1995 WIGWAM RD
EL PASO COUNTY, CO

**GRADING & EROSION CONTROL PLAN
GRADING PLAN**

C1.2 MVE PROJECT 61180
MVE DRAWING GEC-GP

GRADING & EROSION CONTROL PLAN
POND PLAN

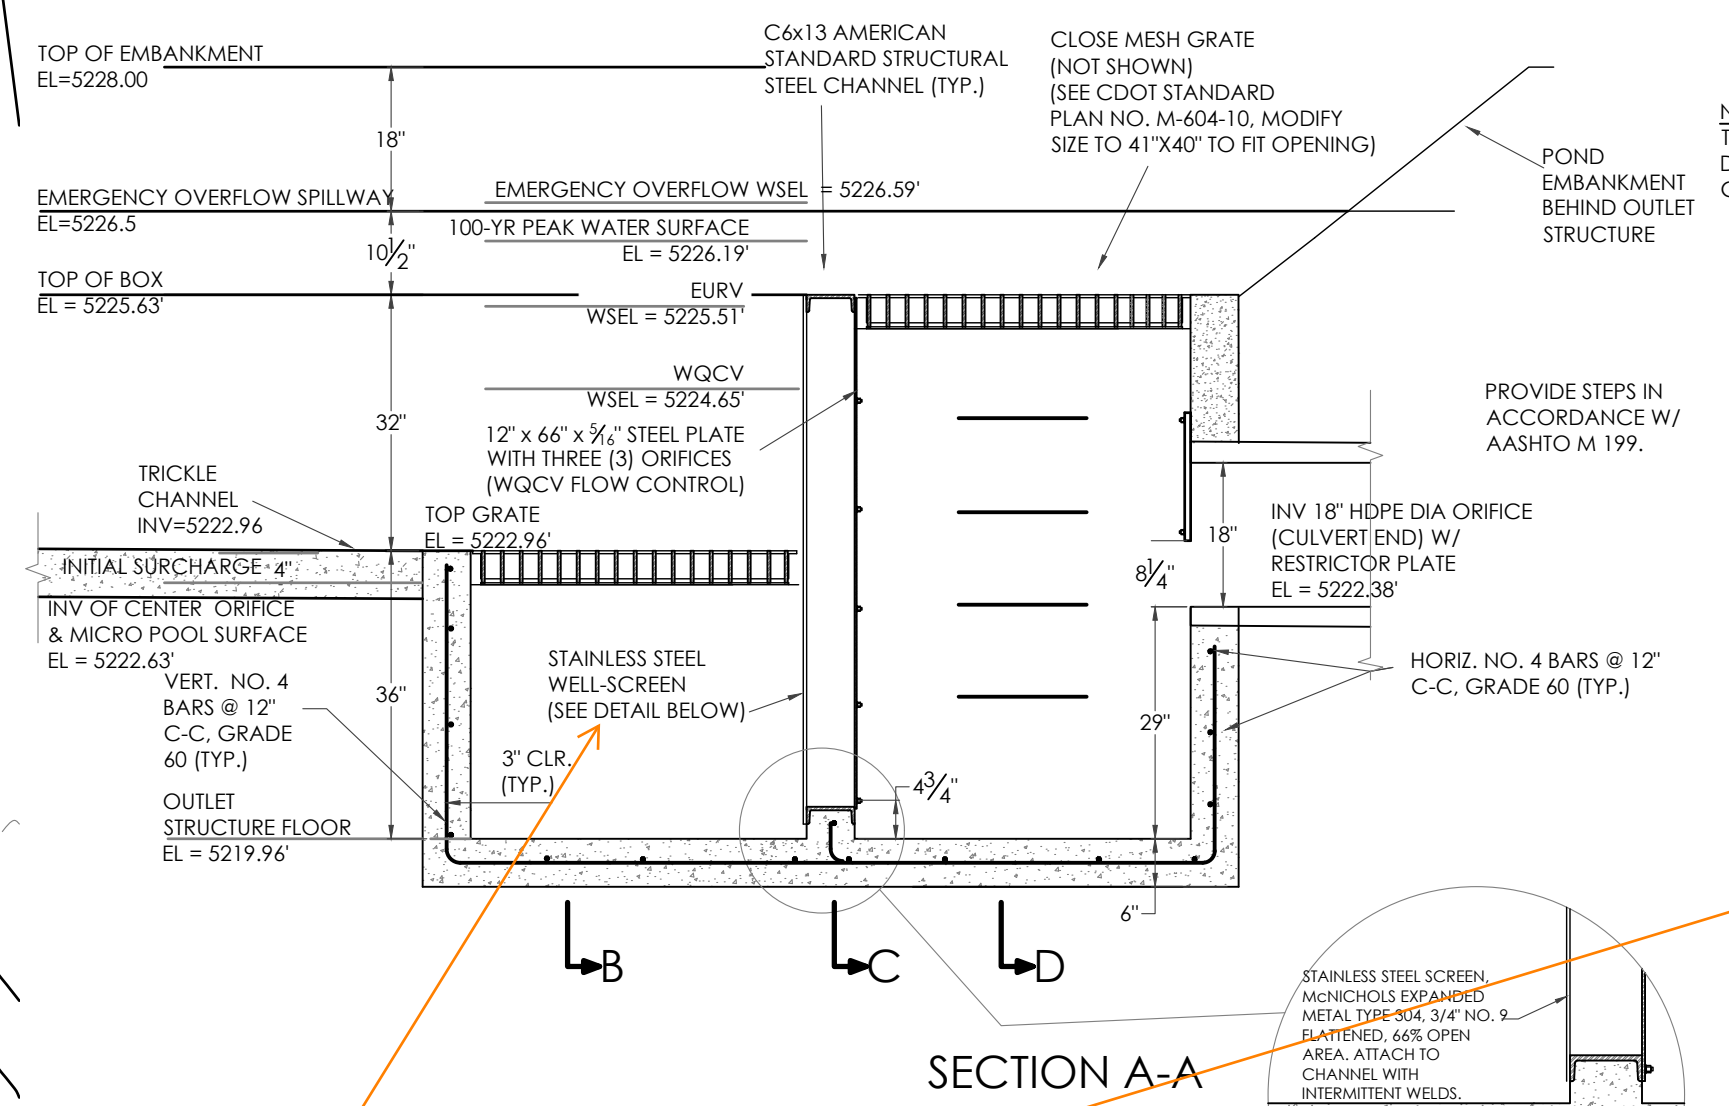
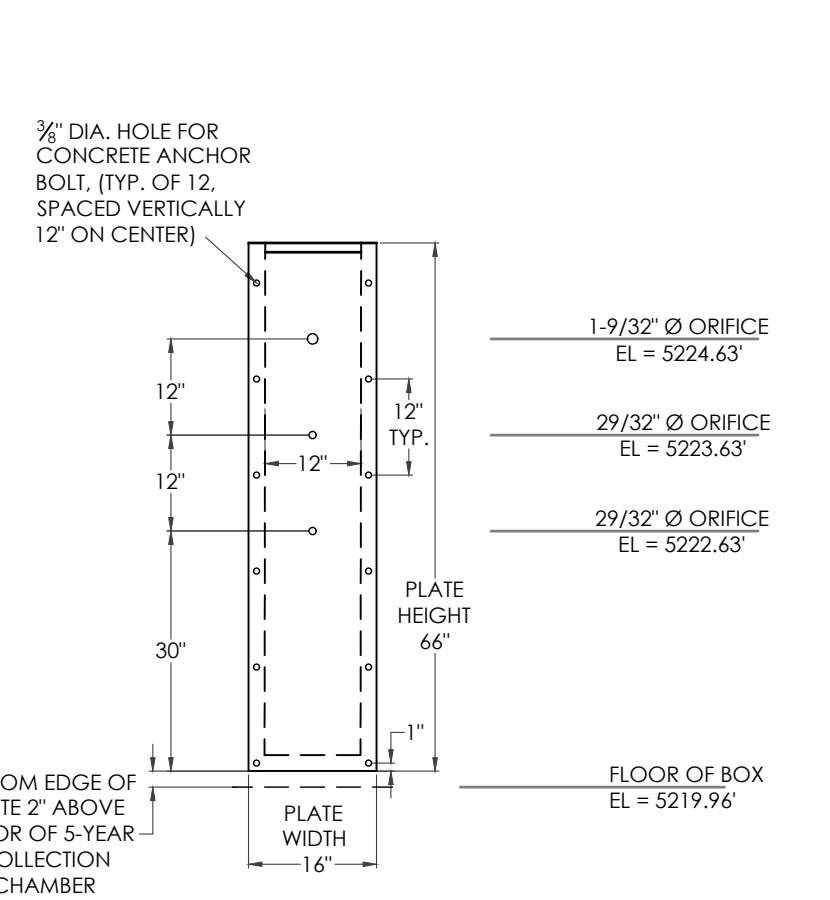
Include callout for pet waste station(s) around the pond, with signage stating that pet waste must be picked up.

These do not match the FDR values - verify and update so both match.

Assign a name/number to all PBMPs and then update all submitted text and drawings accordingly with consistent labeling throughout (example: "Pond A" or "Pond 1").

Specify well screen type. Trash rack to be Johnson stainless steel well screen with #93 VEE wire (Figure 6-a), or equivalent (per EPC DCMv2, Chap 4.3 and MHFD Detail T-12).

show interface between riprap rundown and forebays so it is clear how the two are designed to meet

Number 9 was not shown on the plan. Warning sign location for the pond needs to be shown on the map.

Details of trickle channel, and forebays cannot be fully reviewed without calculations.

Consider having control joints every ~10ft.

show forebay notch view and dimensions.

GRADING & EROSION CONTROL PLAN

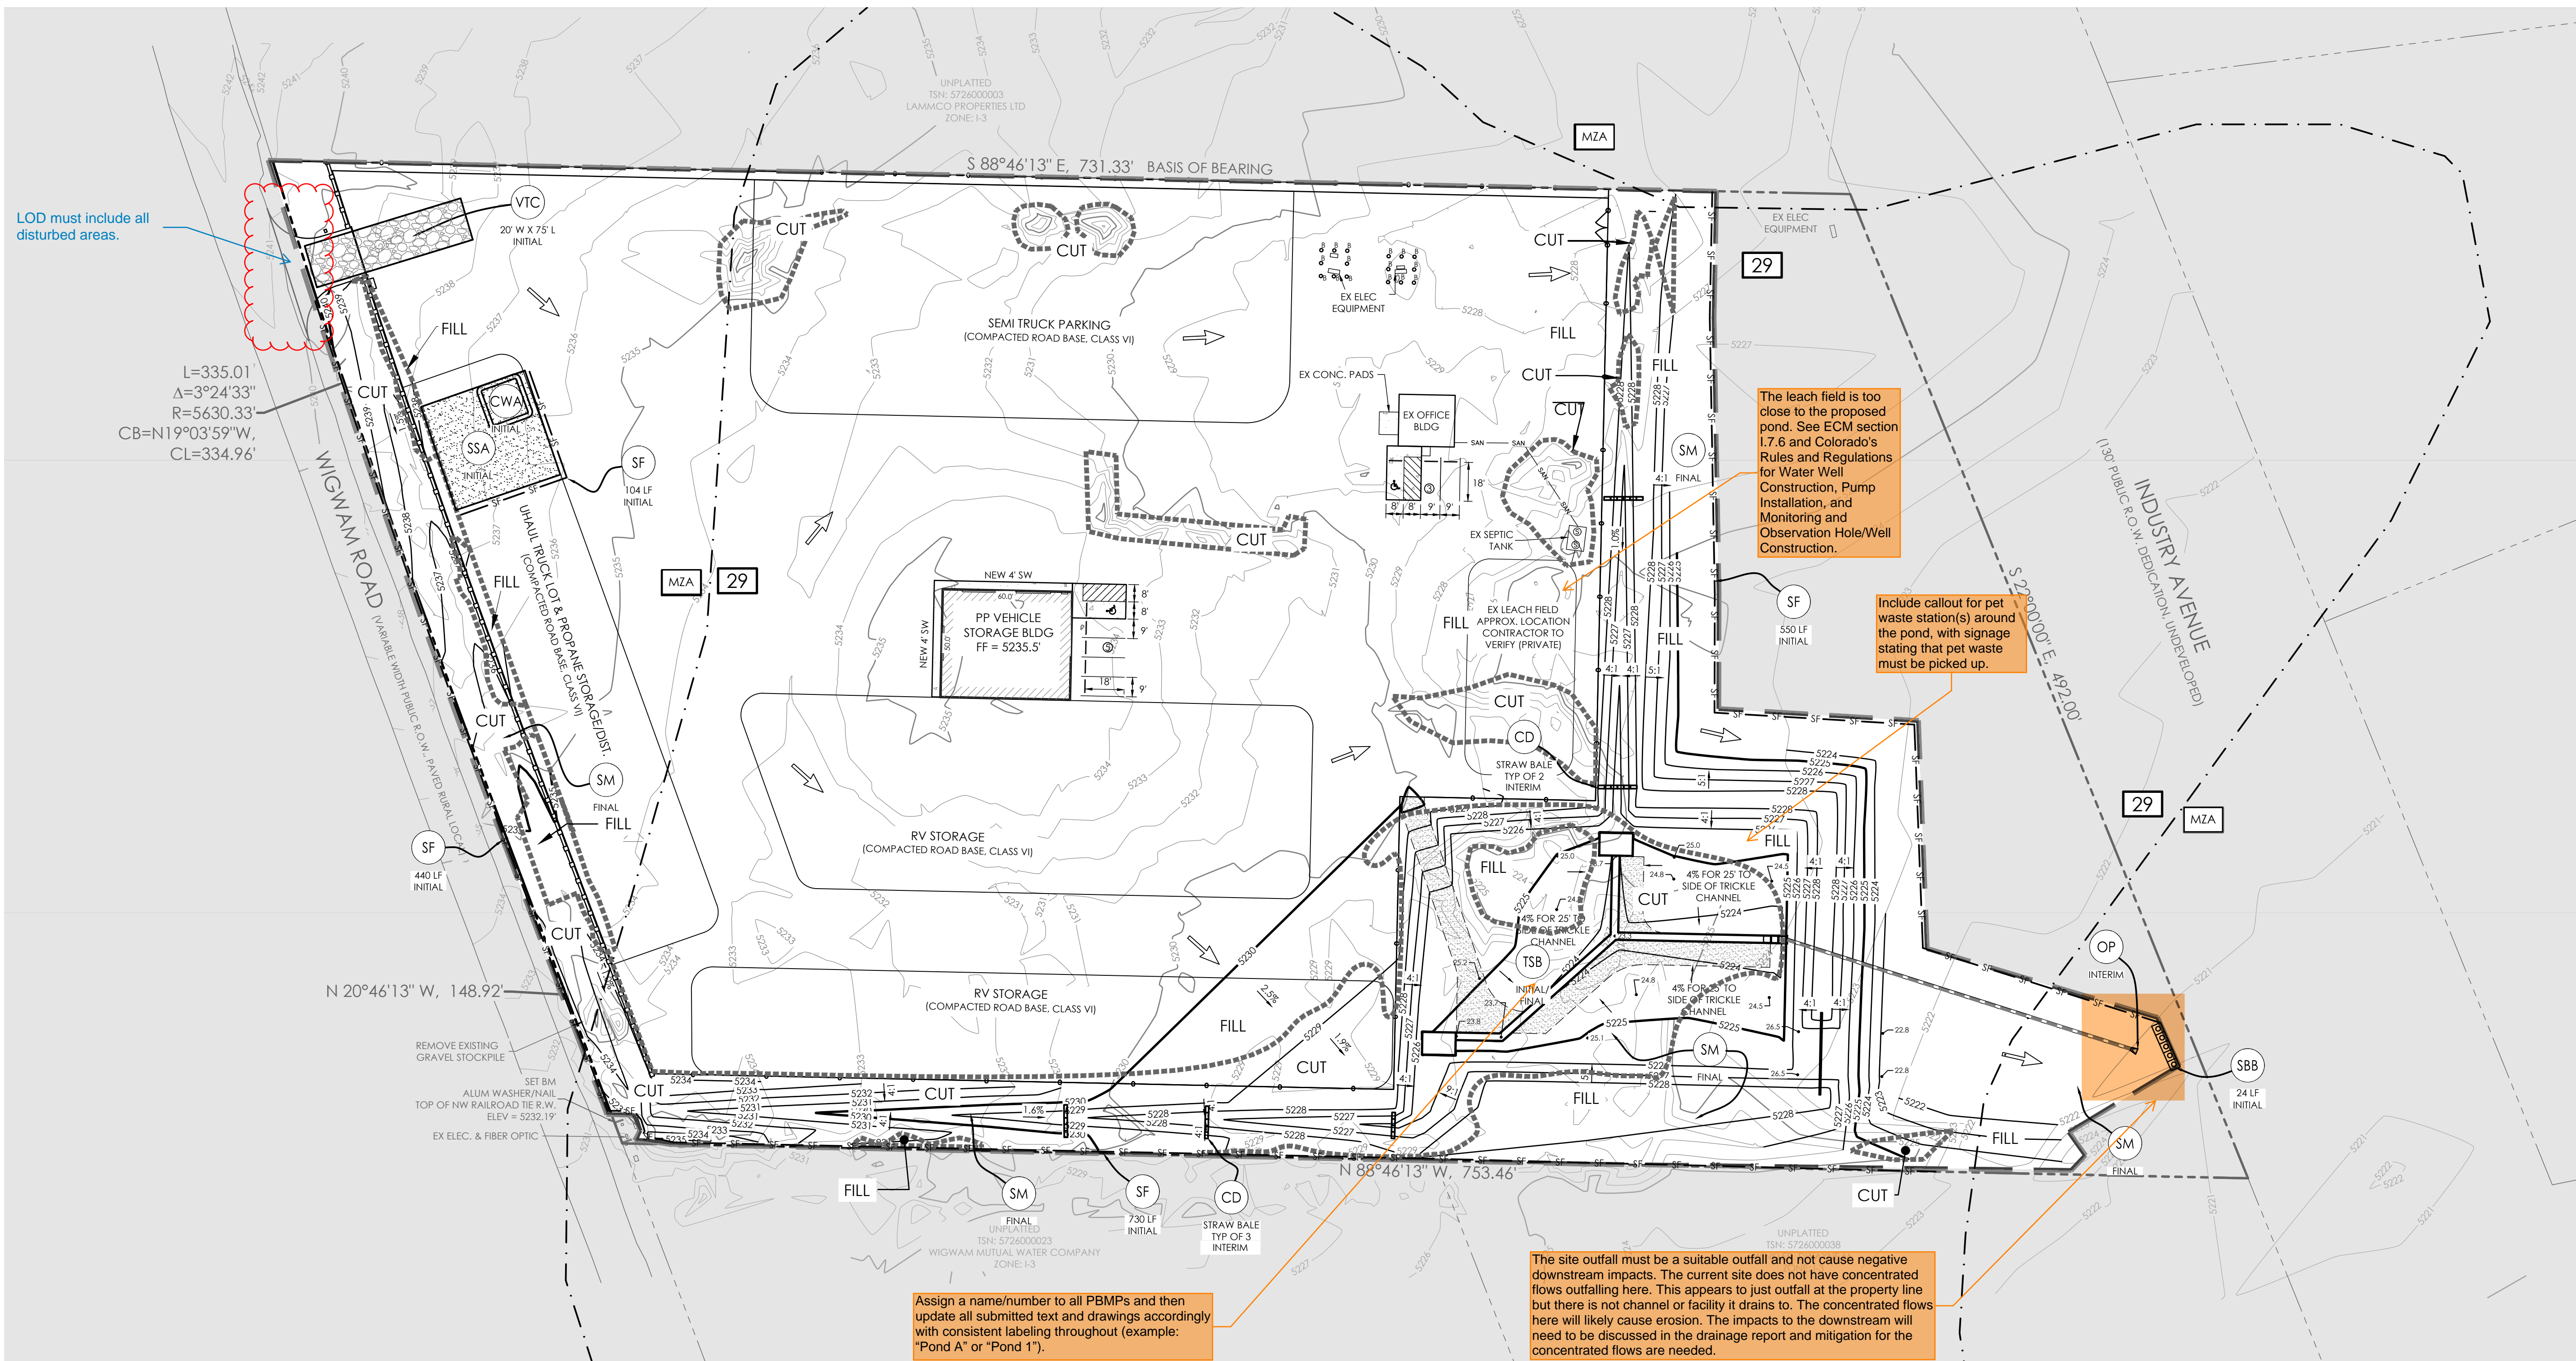
LOD must include all disturbed areas.

The leach field is too close to the proposed pond. See ECM section 1.7.6 and Colorado's Rules and Regulations for Water Well Construction, Pump Installation, and Monitoring and Observation Hole/Well Construction.

Include callout for pet waste station(s) around the pond, with signage stating that pet waste must be picked up.

Assign a name/number to all PBMPs and then update all submitted text and drawings accordingly with consistent labeling throughout (example: "Pond A" or "Pond 1").

The site outfall must be a suitable outfall and not cause negative downstream impacts. The current site does not have concentrated flows outfalling here. This appears to just outfall at the property line but there is not channel or facility it drains to. The concentrated flows here will likely cause erosion. The impacts to the downstream will need to be discussed in the drainage report and mitigation for the concentrated flows are needed.

Verify, this should be interim because the ditches are proposed and so this could not be an initial CM.

This percentage should match what is in the SWMP for reference. The percentage is very low. The coverage should not represent the percent of the site that is vegetated, but the density of the vegetative coverage of the previous area on site. If site was previously graded or land use was such that there is no or minimal vegetation, the % cover required for final stabilization should then be based on neighboring properties to show natural native vegetative cover (ie: an adequate reference site). If surrounding sites are also being developed, use historic aerial photos to make determination.

If this note is intended to represent the % of the site area that has vegetation reword so that it is clear the % is different from what the SWMP % represents.

GRADING & EROSION
CONTROL PLAN
EROSION DETAILS

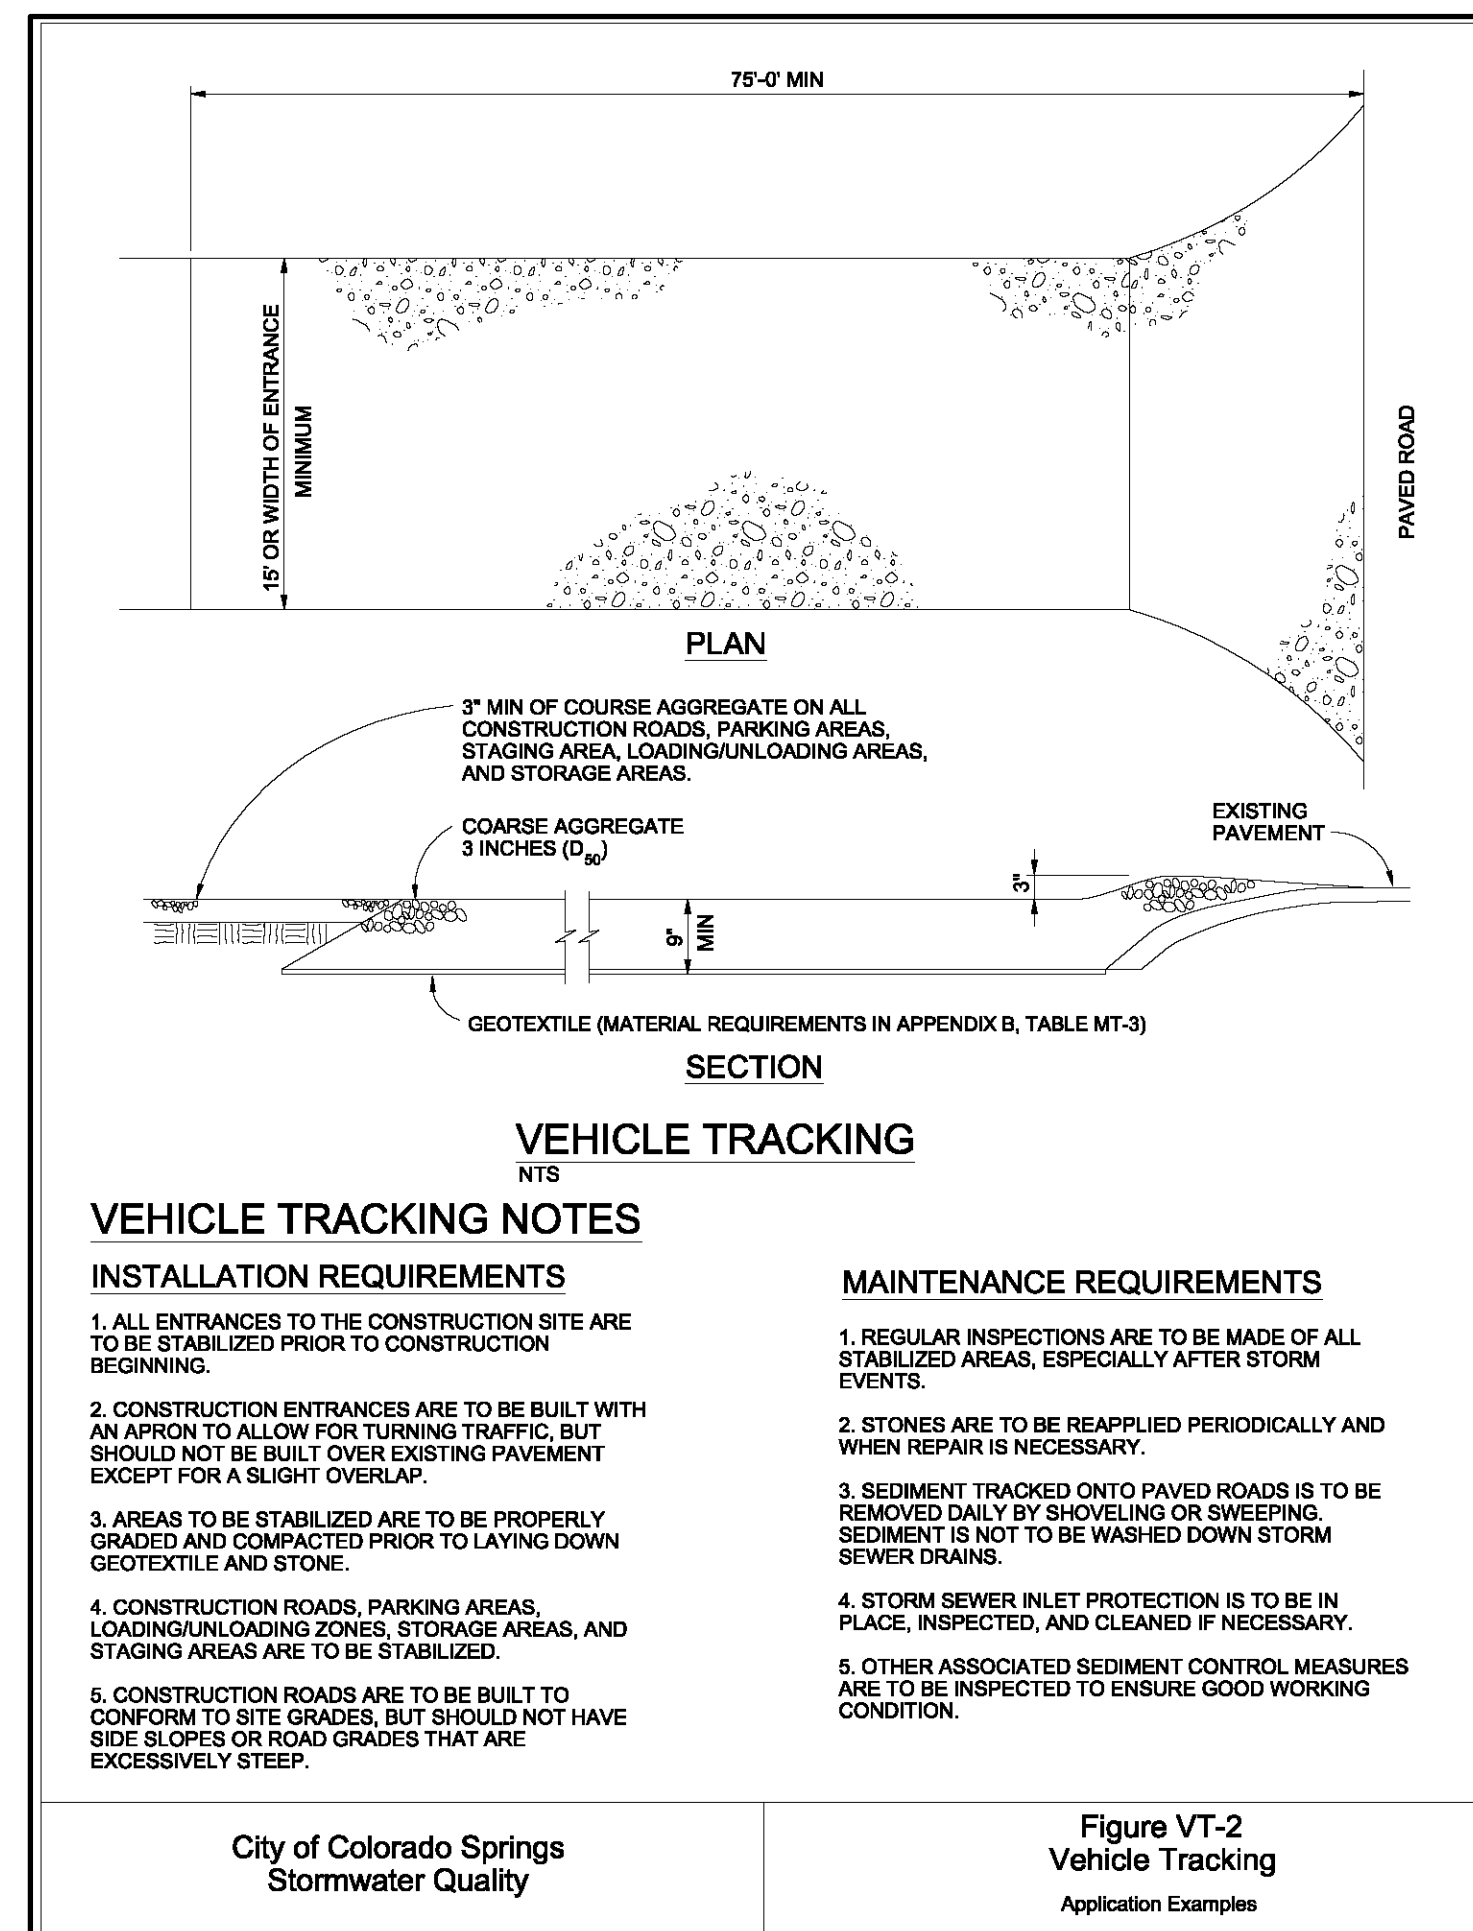
GEC Checklist Item z - Provide all detail. Provide the details for the permanent outlet protection and the temporary outlet protection.
